PLAN COMMISSION REPORT

Plan Review

Description:	Site plan review for a proposed addition to the existing parking lot					
Applicant(s):	Nick Newman, Kwik Trip, Inc.					
Address(es):	9535 S. 13 th Street (5 th Aldermanic District)					
Suggested Motion:	That the Plan Commission approves the site and building plans submitted by Nick Newman, Kwik Trip, Inc. for the addition to the existing parking lot on the property at 9535 S. 13 th Street with the following conditions:

SP 1.0

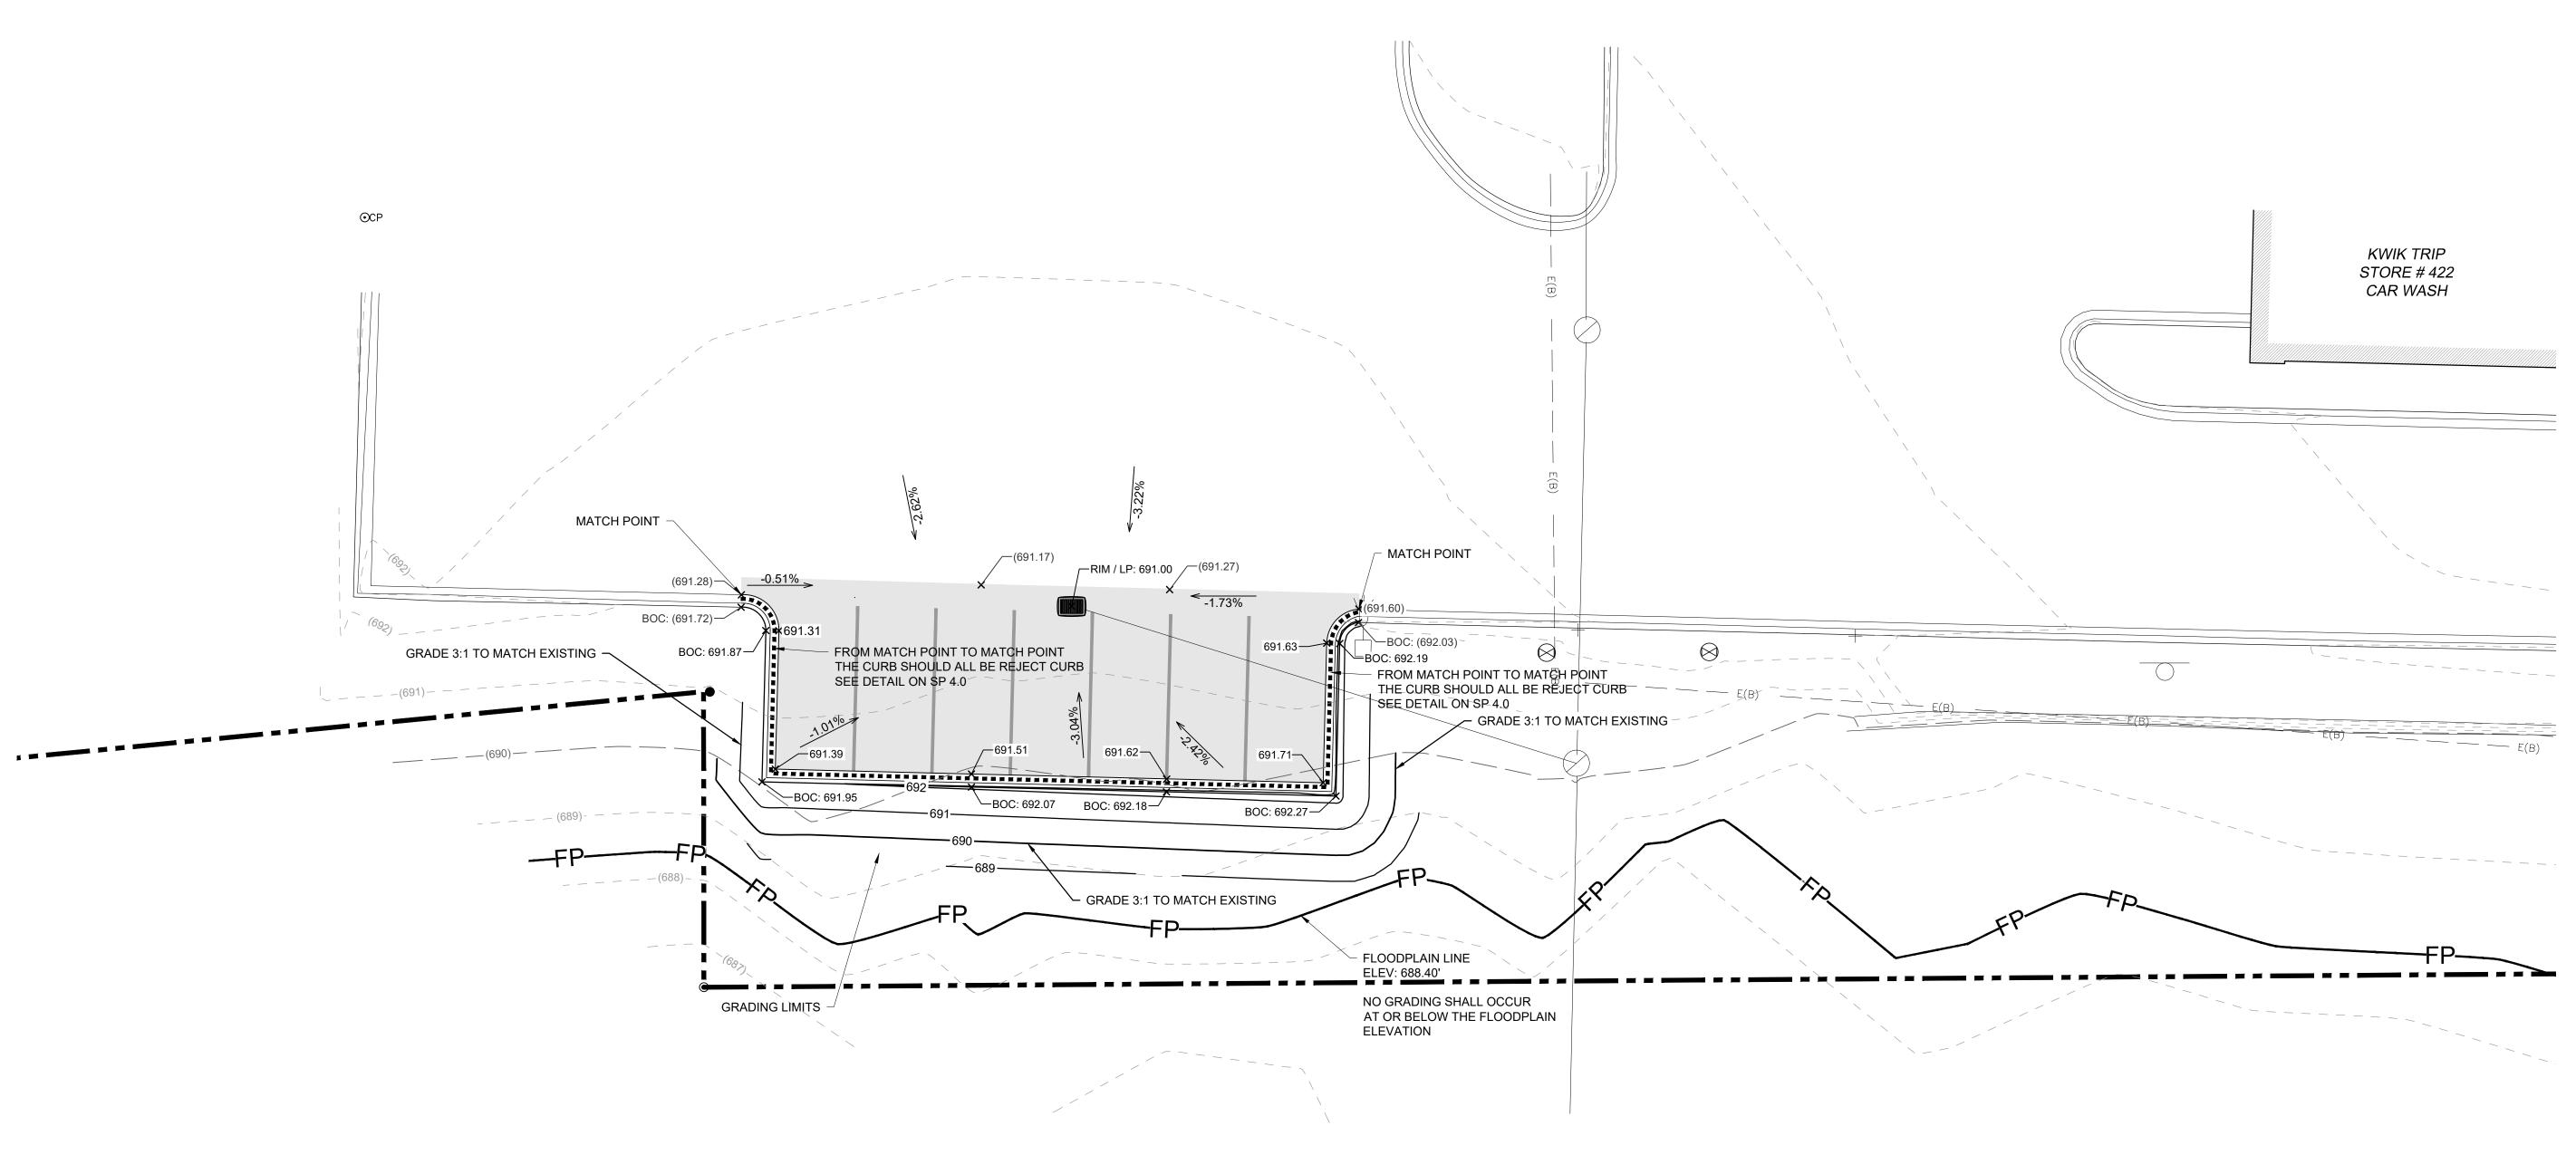
- In the proposed plans, it appears that the parking lot expansion will comply with the required 15-foot side setback, but this dimension is not labeled in plans and should be verified.

- Property in the B-4 zoning district may not exceed 70% lot coverage per Code. The proposed parking lot expansion will add 1,324 square feet of impervious area lot coverage. However, current plans do not indicate the current lot coverage percentage for the site.

1. That all relevant Code requirements remain in effect.					
	That the plans are revised to include setbacks for the additional parking spaces.					
	3. That the plans are revised to include impervious and green space calculations.
